Access Compliance Report

Public Rights-of-Way

Intersection ID: 28141	Main Street: PROVIDENCE_RD_WEST	Cross Street: OLD_ARDREY_KELL_RD	Location: SW
ADA ID: 97B1E457C315	Ramp Type: Perp	Initial Pass/Fail: Pass	Overall Compliance: No
Severity Score: 2.5			
Codes/Mitigation Info/Possible Solution		Field Measurements/Component Compliance

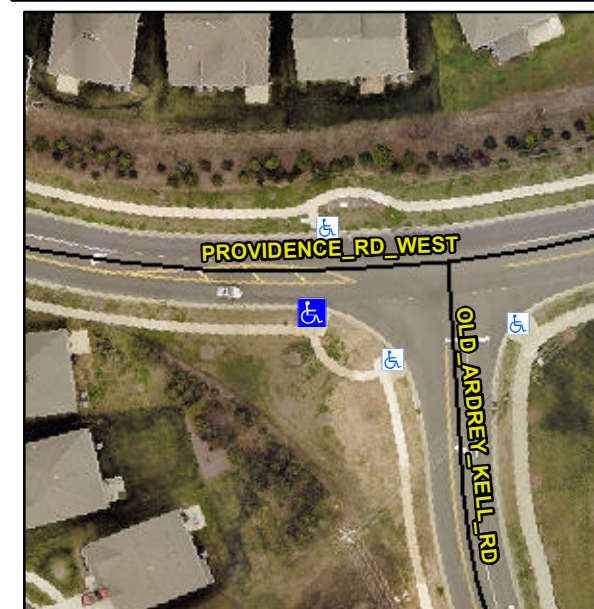
Remove & Replace Detectable Warning System.

R305.1.4, R305.2
